From: Oswald, Hank
Sent: Friday, April 21, 2017 10:44 AM
To: 'MIKE@ELITEPOOLS.COM'
Subject: B16005209_12815 Macbeth Farm Lane_Spa Addition
Attachments: file.pdf

Amendment, Permit # B16005209

AS-BUILT FOUNDATION PLAN
MACBETH FARMS
12815 MACBETH FARM LANE
LOT #35
PLAT M.D.R. NO. 10791
5th ELECTION DISTRICT, HOWARD COUNTY, MARYLAND
FOR N.V. HOMES

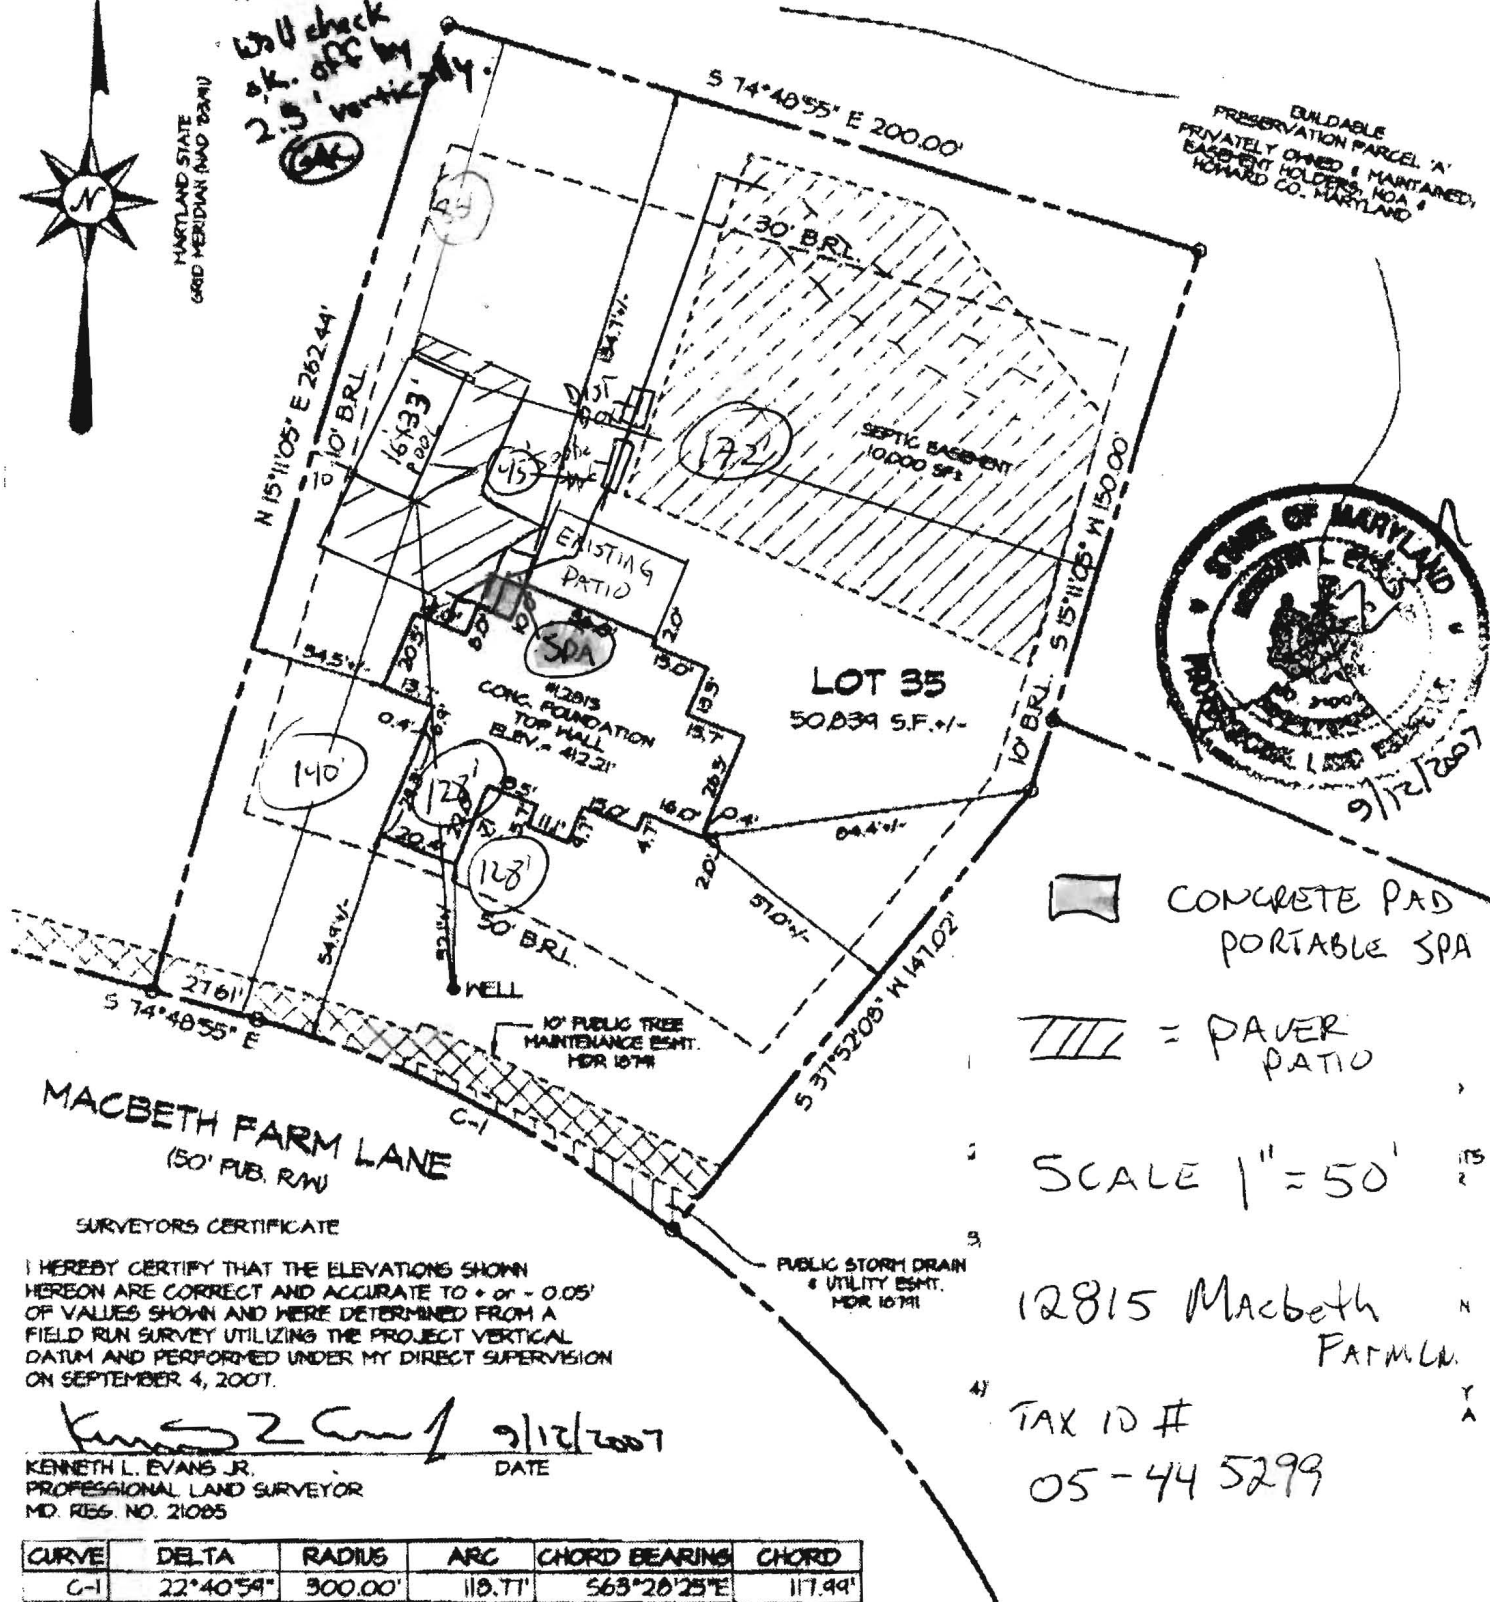
Quick question regarding the spa addition to 12815 Macbeth Farm Lane. Does the homeowner know that the proposed spa/pad will be constructed over the septic line? Please see attached As Built for details. It should be fine but be mindful of it during the construction phase of the project.

A518543-F

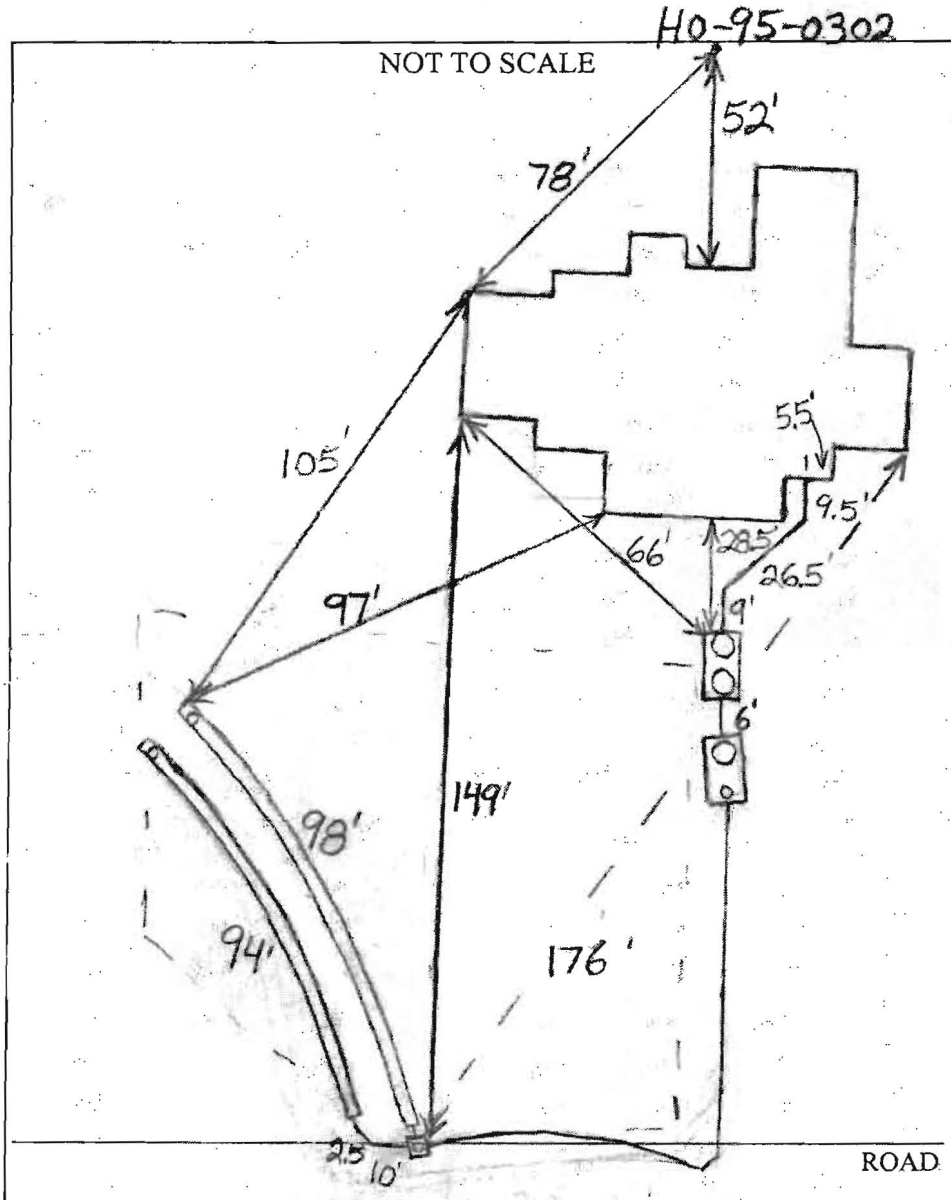
PRE-CONSTRUCTION 10/26/07 Pumped system required. Place the distribution box near perc. test hole 748 and in-

INSTALLATION stall a 100' and 94' trench on contour towards the house. (BB) 11/6/07 Tanks installed. Trenches installed. Need rear baffle in primary tank. Distribution box appears to be on neighbor's property. Asked installer to move box. Also need pump and alarm test and manhole risers. (BB) 11/8/07 Need pump and alarm test. Distribution box moved. (BB) 12/2/07 Pump and alarm working. (BB)
